## SERVICE INFORMATION BULLETIN

**APPLICABILITY:** 2014-2019MY Forester  
2013-2019 Crosstrek

**NUMBER:** 05-69-19

**SUBJECT:** Rear Subframe Bolts: Design Change

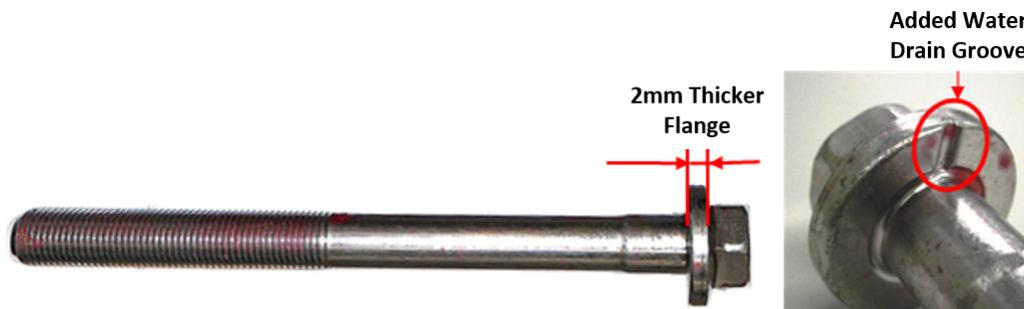
This Service Information Bulletin announces a change made to the rear subframe retaining bolts used on the models listed above. The design changes provide the bolt with an increased durability against rust.

The part number for the new subframe flange bolt is **20058FL000**. The changes made to the bolt (thicker flange and addition of a drainage groove) are shown in the photos below.
